Summary and recommendations

Pilbara Energy Limited (the proponent) proposes to establish an energy infrastructure in the Pilbara region of Western Australia (Figure 1). This proposal will provide natural gas and electric power for future industrial developments and includes:

**Questions and issues raised in submissions
and the proponent's response**

Figure 14

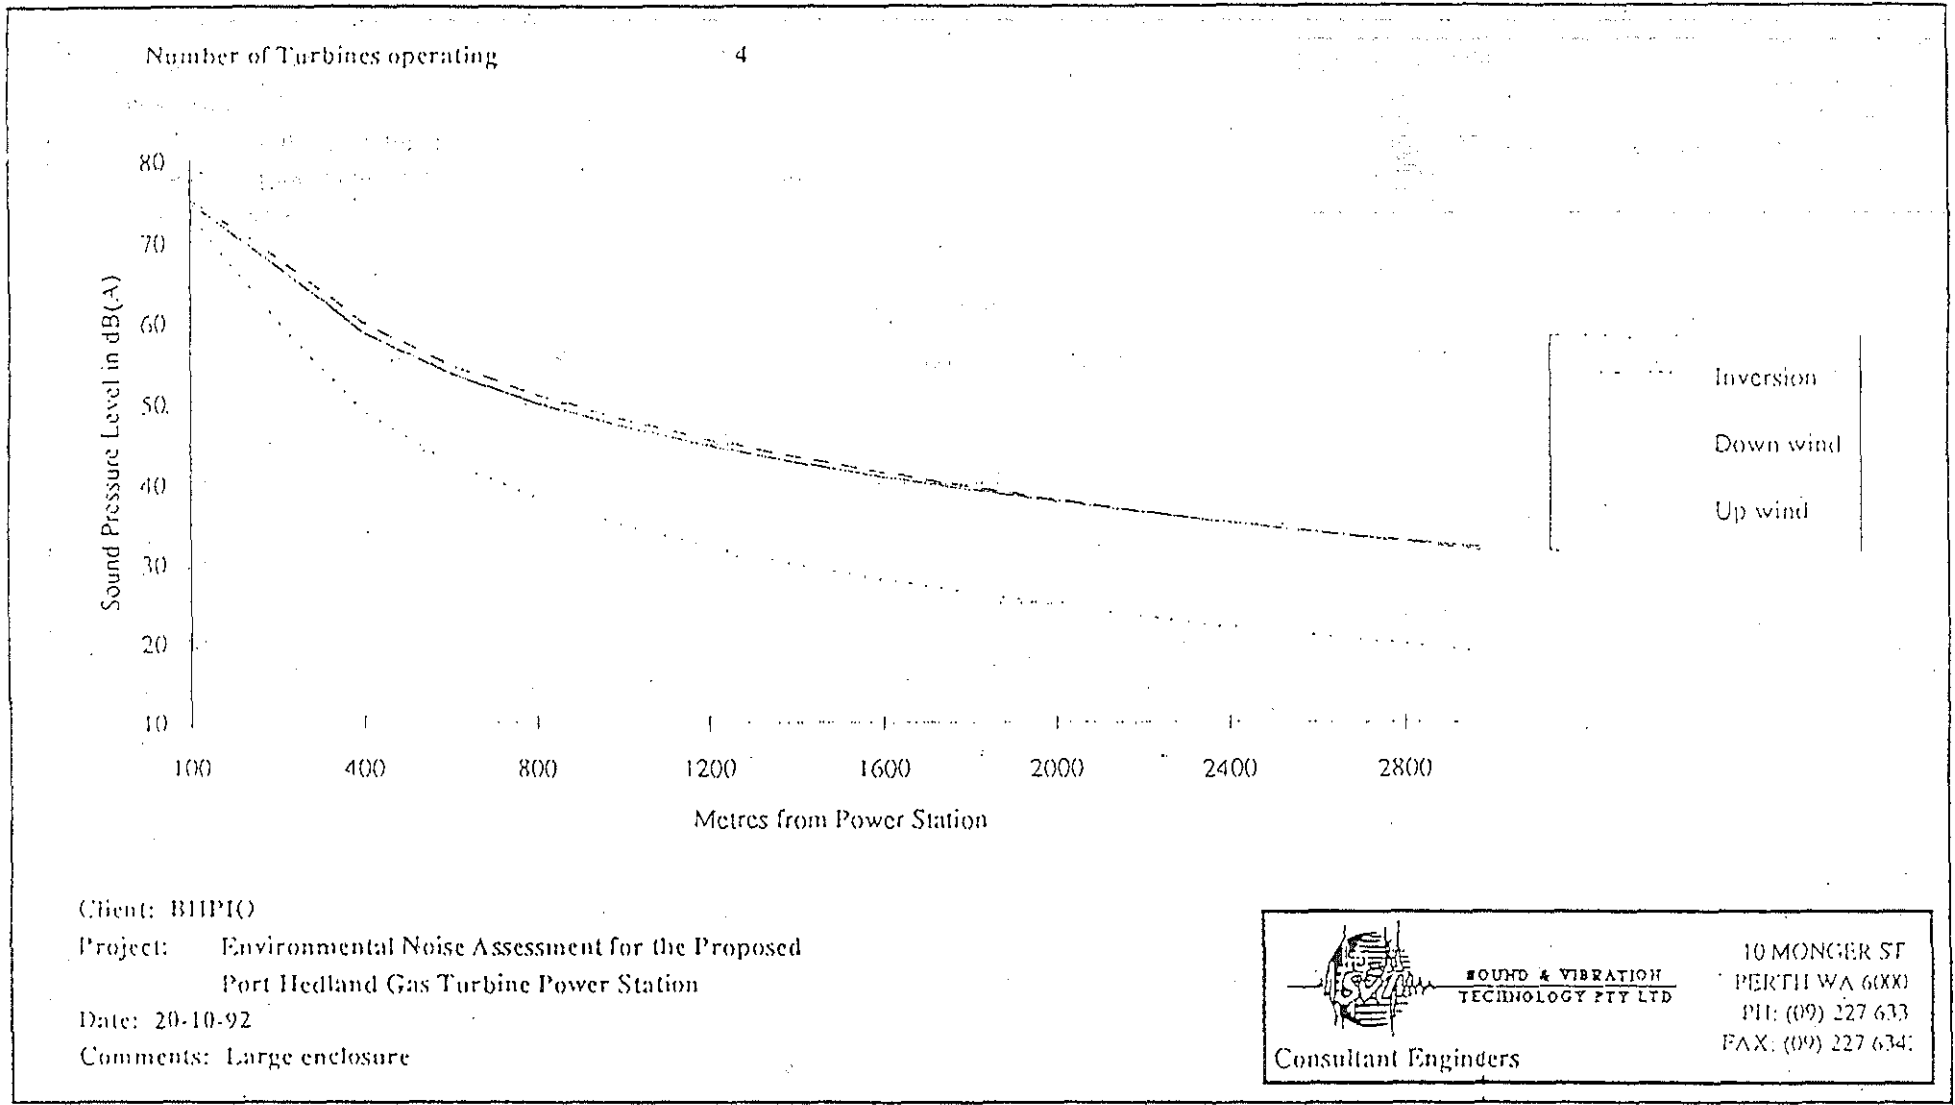
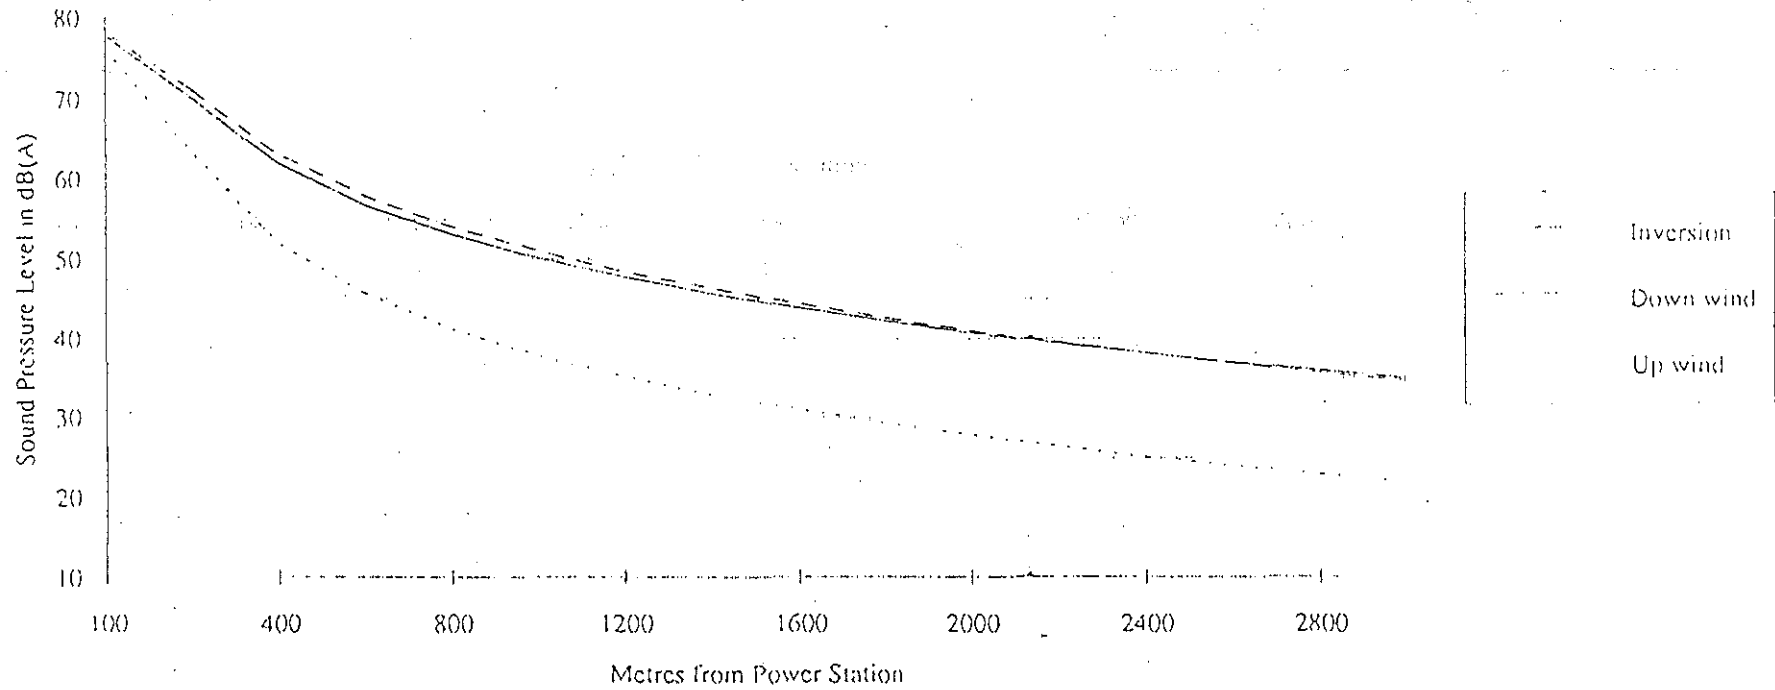
7.2 Q *Are there any climatic conditions during which noise and gaseous emissions are predicted to impact on residential areas? Provide modelling contours of the worst case noise scenario.*

The attached figures 13 and 14 show the sound propagation curve for 4 and 8 GT's operating.

Figure A.1.4.1 Quarry Road site, Summer conditions, four Turbine operating with large enclosure

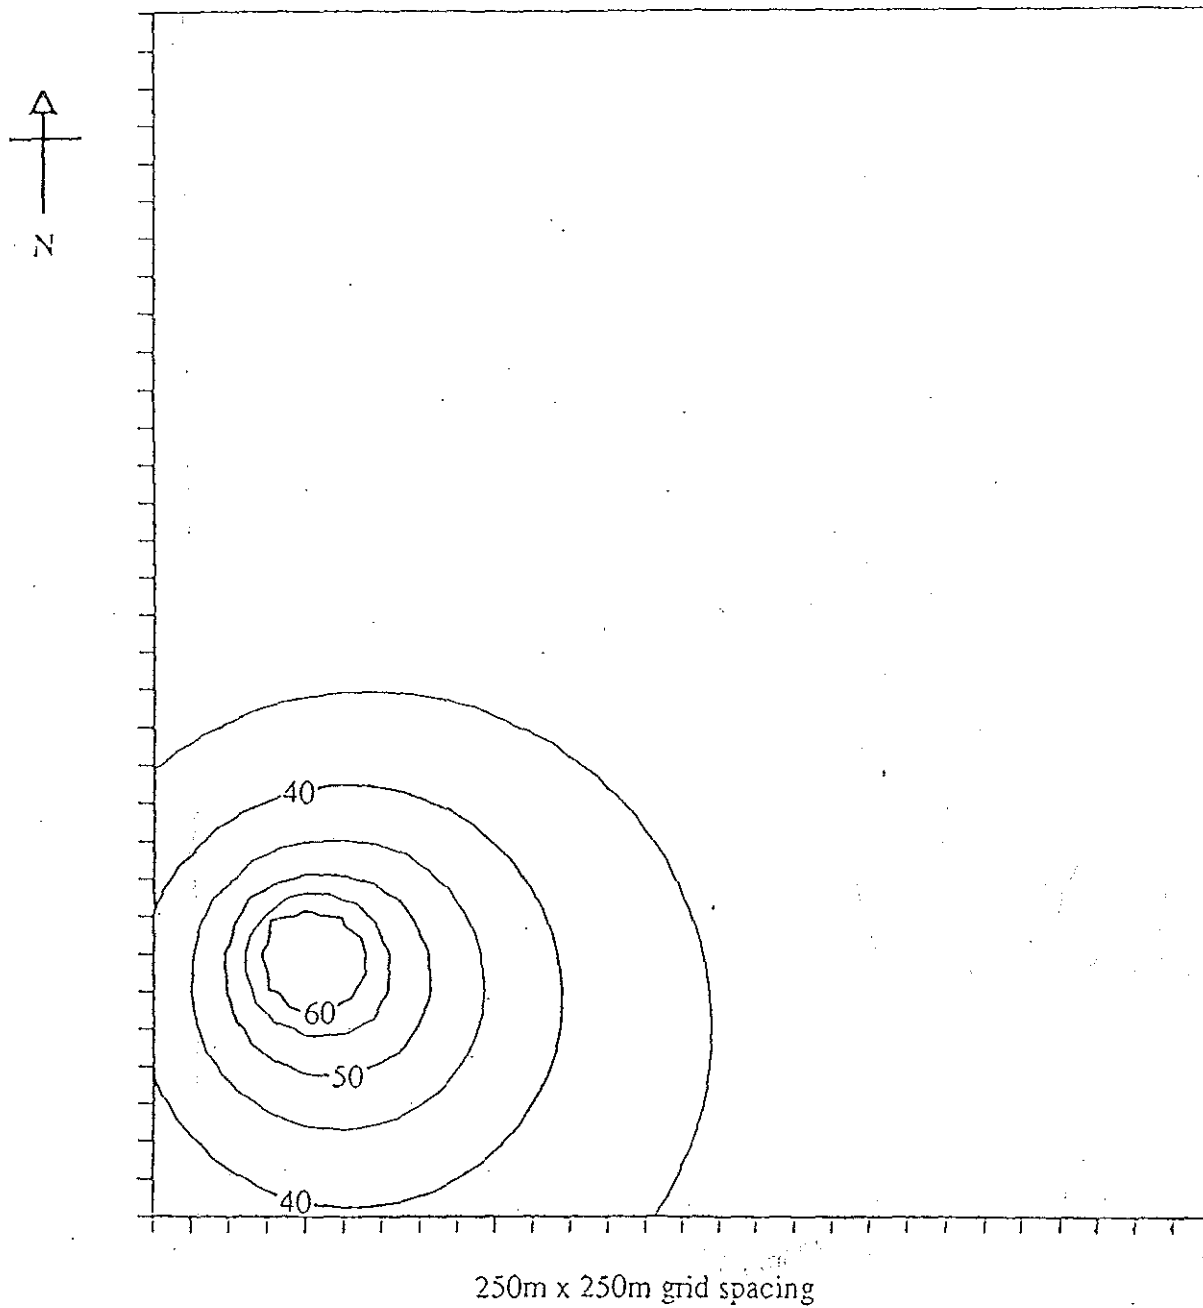
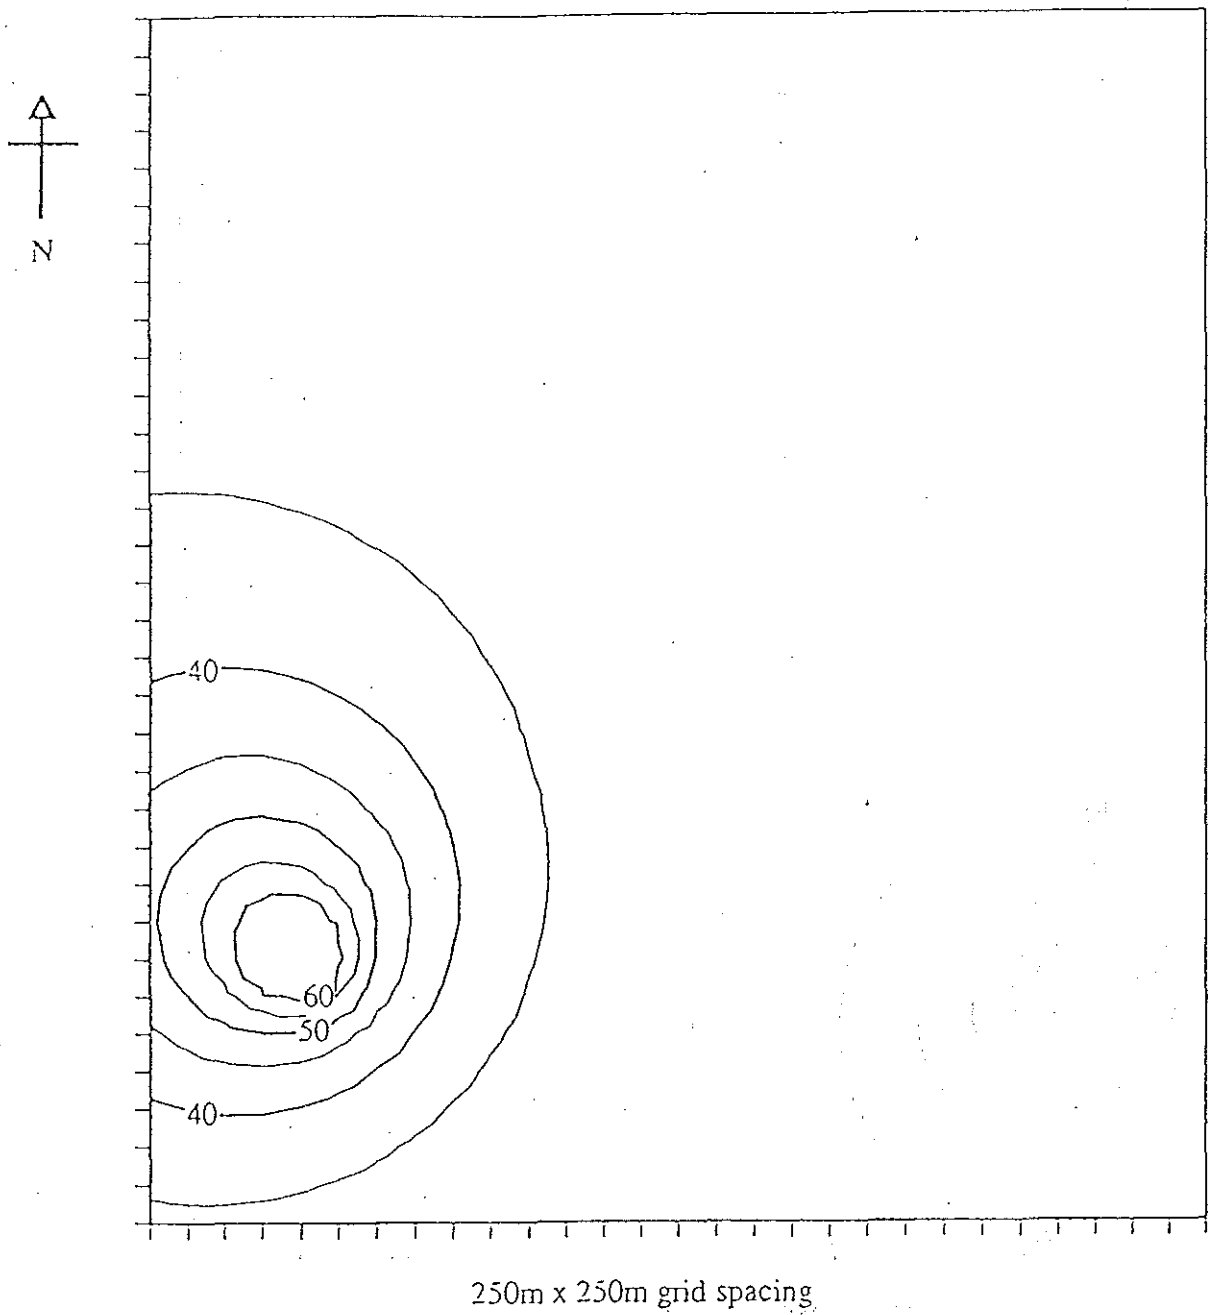
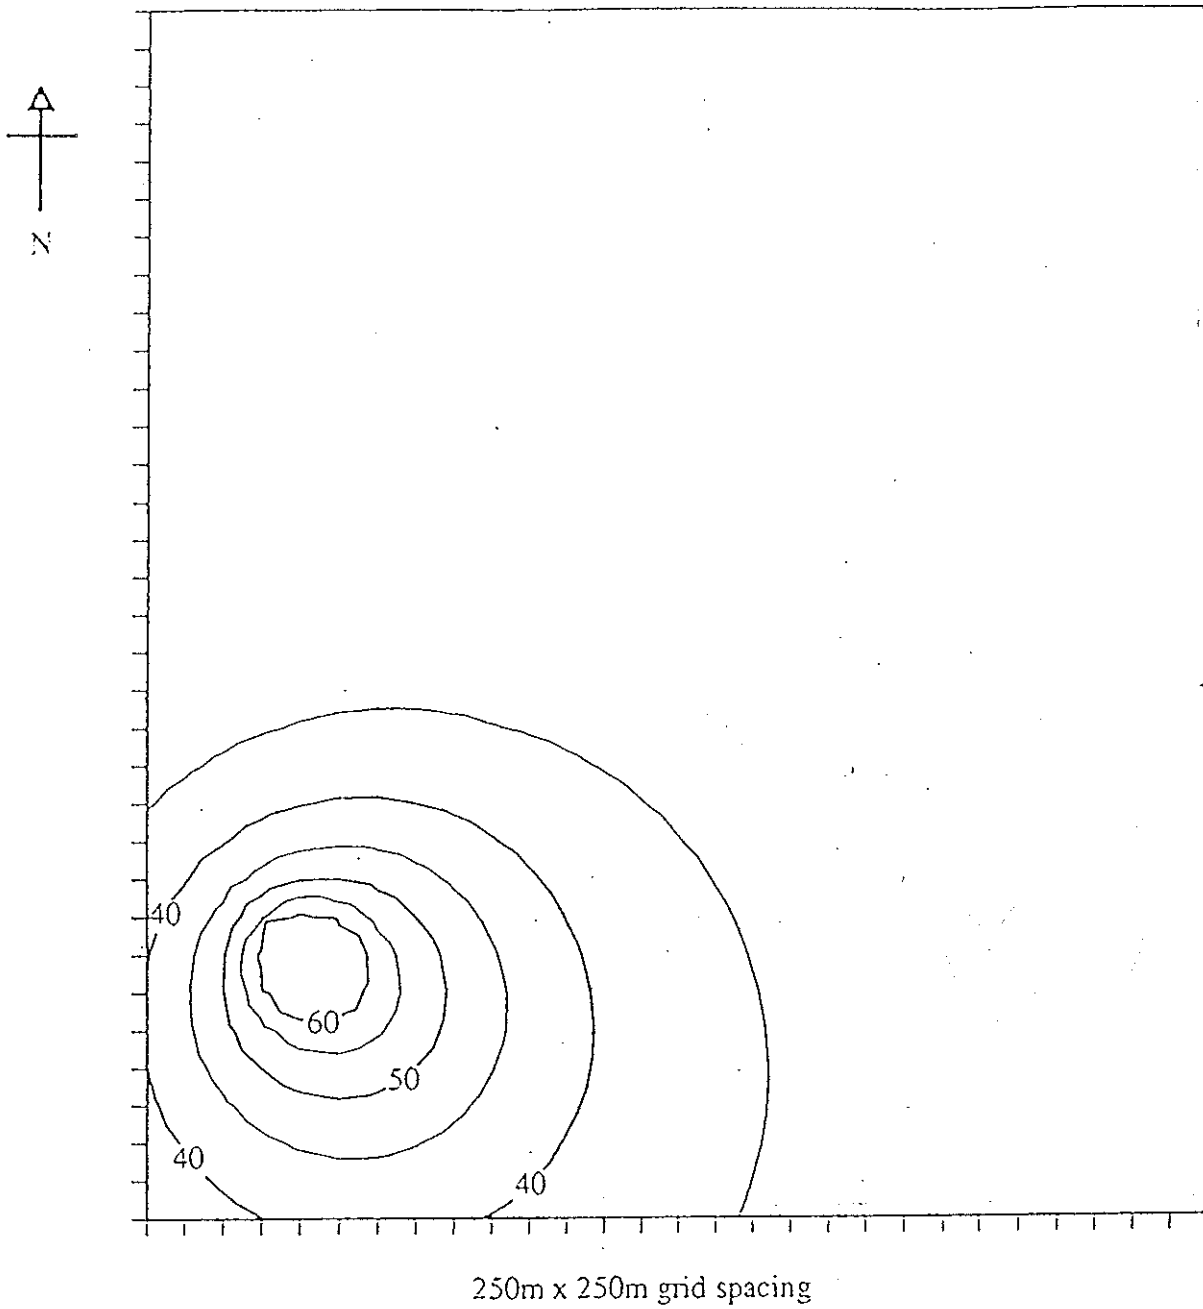
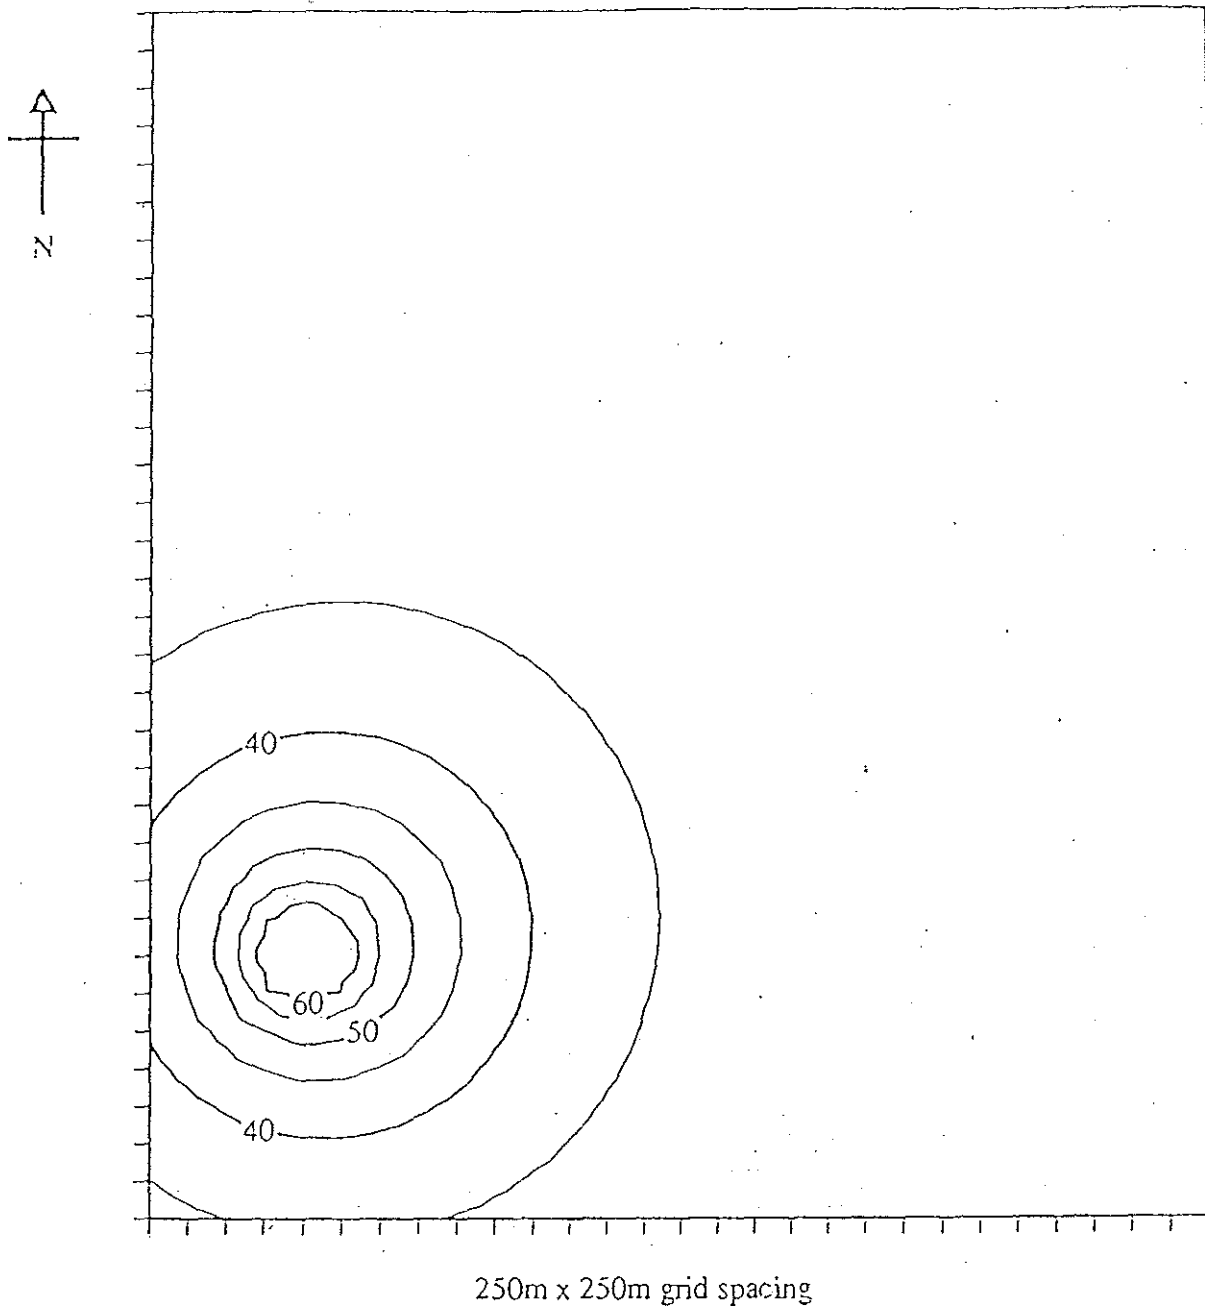
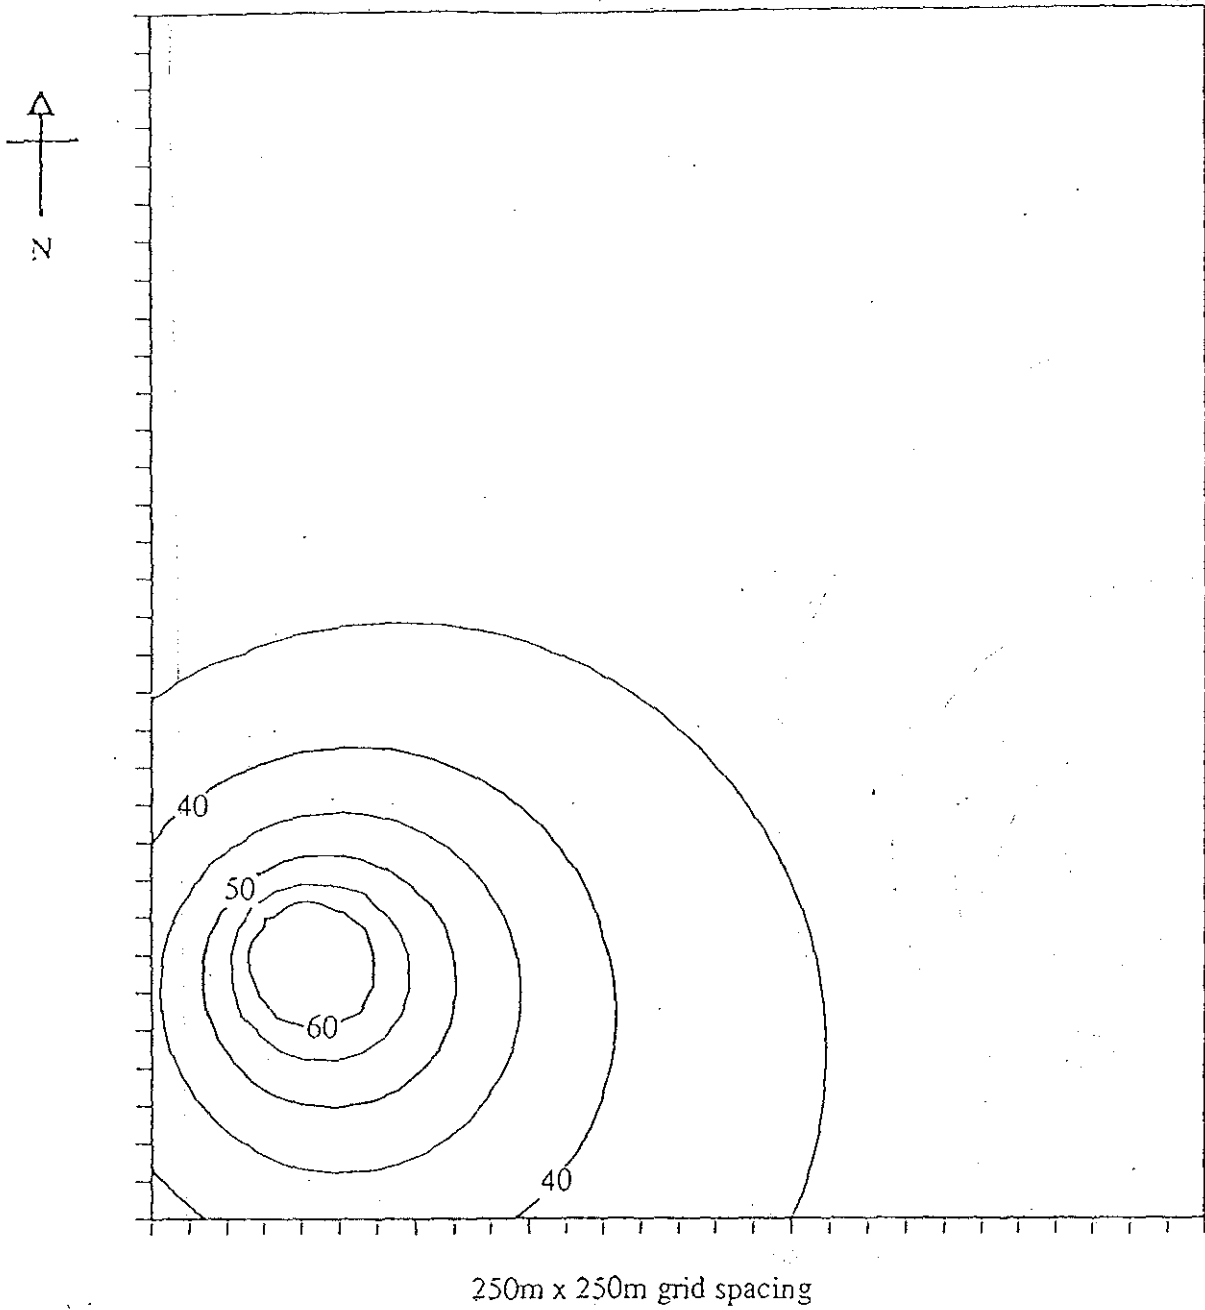
7.1 Q *Elaborate on the 35 dB (A) noise contour in figure 2.1 i.e. what wind conditions (times, seasons etc) does this relate to?*

Figures A1.4.1 to A4.4 show the noise contour with four GT's operating and Figures A1.6.1 to A6.4 show the contours with 8 GT's operating during summer, autumn, winter and spring. These contours are for a site on Quartz Quarry Road, which is no longer viable, but the figures are applicable to the selected power station site.
